PRODUCT CHANGE NOTIFICATION

RP2 Carrier Tape Dimension Changes for Select 3-Electrode Miniature Gas Discharge Tube Products

Model 2036 and 2038 Series

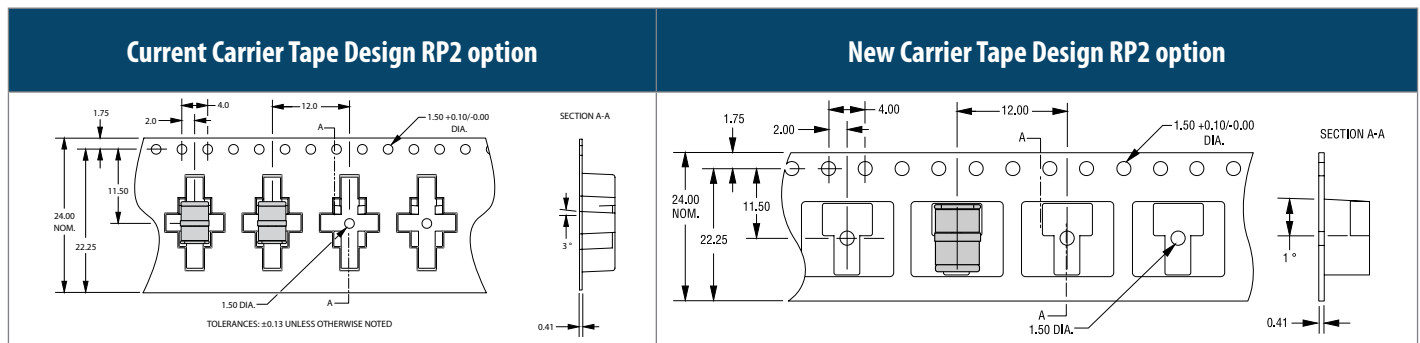
Riverside, California – February 25, 2020 – In the spirit of continuous improvement, Bourns is changing the design of the RP2 carrier tape for select Model 2036 and 2038 series 3-Electrode Miniature Gas Discharge Tubes. The carrier tape pocket design is being changed to help prevent parts from moving position during shipping. There is no change to the electrical characteristics of the products. A list of affected part numbers is included below.

These changes have no impact on the form, fit, function, quality or reliability of the affected products. The product marking and label will remain unchanged. The carrier tape dimension changes will affect the fit and form of the packaging as shown.
